Delegated Report

Planning Application No: 20240198

Location: Land At Rosherville Way And Crete Hall Road
Northfleet Embankment East
Employment Southern Parcel
Rosherville Way
Northfleet

Description: EDC Consultation EDC/23/0163 - Development of previously developed land to provide an employment park containing five buildings (Building 1 three storey, Buildings 2 to 5 of two storey height) comprising Use Classes E(b) (Food and Drink), E(g)(i) (Office), E(g)(ii) (Research and Development), and E(g)(iii) (Light Industrial) with new site access from Crete Hall Road, parking and landscaping following demolition of a remnant building.

Table 10.1: Summary of Recommended SSD Criteria

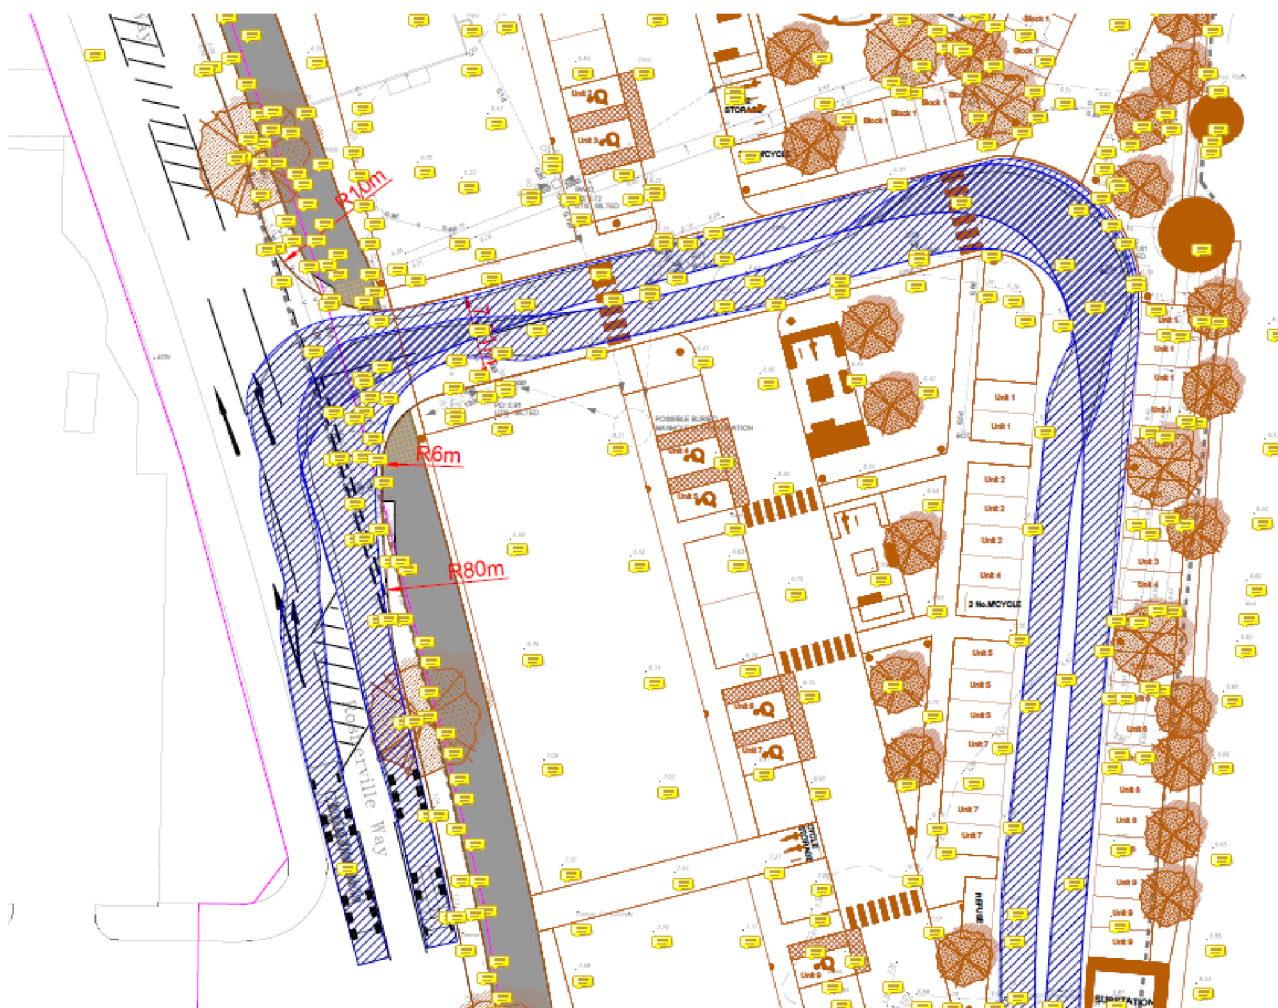
This increases the sight line requirement at 10mph to 12 metres, which is only a small increase, but an essential one when considering pedestrian and cyclist safety. Obviously, any increase in junction radii, would increase vehicle speeds and in turn visibility requirements. The radii at the junction is a matter for the Highway Authority as it will form part of the adopted highway and this should be agreed with Kent County Council adoption team prior to planning approval.

Extract from Drawing Number 15706-T-03 Rev P2 dated 29/08/23

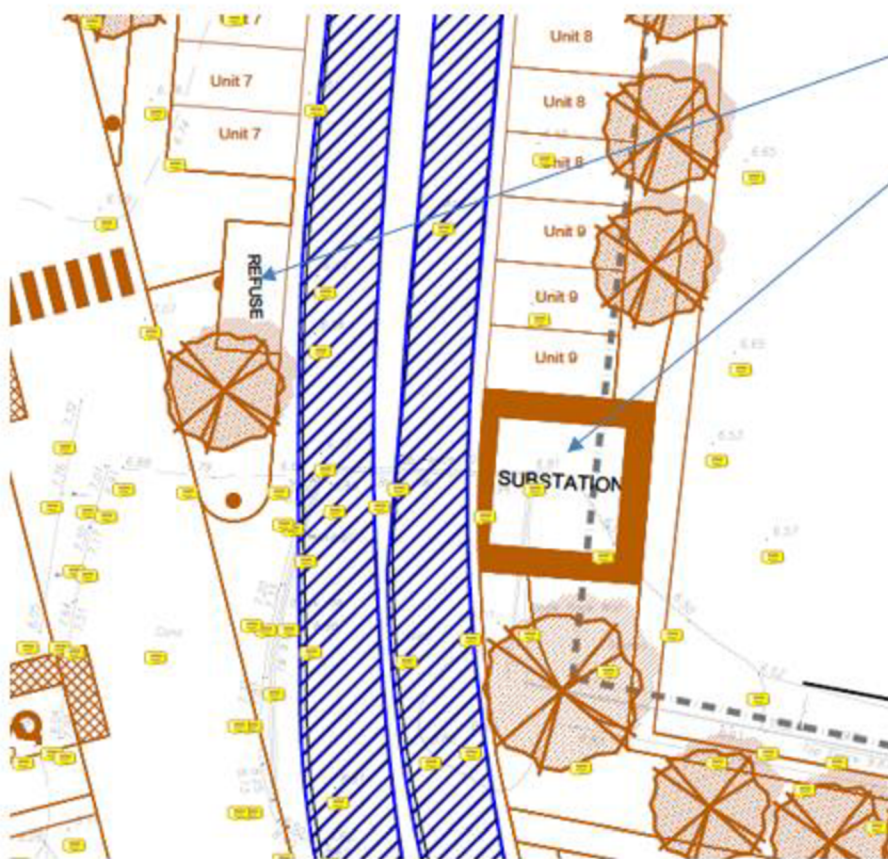
Whilst it is accepted this shows two articulated lorries passing, it does involve some conflicting manoeuvres, which without adequate visibility will compromise highway safety.

1. A vehicle entering the site conflicts with a vehicle emerging and whilst vehicle speeds may be low and so the possibility of a collision may be avoided, it could result in one or both vehicle having to reverse to resolve the situation, and this could be hindered by following traffic. The vehicle entering may not come to a stop in the turning lane if its turn is unhindered by a vehicle travelling south. The radii and visibility should be improved to prevent this occurring.

2. The bend within the site requires vehicles to pass on the wrong side of the carriageway, to prevent collision adequate sight lines need to be provided. This is when people forget that approaching vehicles must be able to stop in time, so a collision is avoided, as such forward visibility needs to be doubled so that vehicles come to a halt just before they collide. So assuming a 10mph design speed the forward visibility requirement would be $2 \times 12\text{m}$ or 24m for HGV's. This would equally apply at any other collision point with distances varying depending on the design speed. Forward visibility splays should be plotted for the spine road for all relevant areas and the measures taken to ensure the design speed can be clearly achieved shown.

It is noted that the sight line for vehicles emerging from the spaces currently allocated to Unit 9 could be compromised by the proposed substation and for unit 7 by the refuse store.
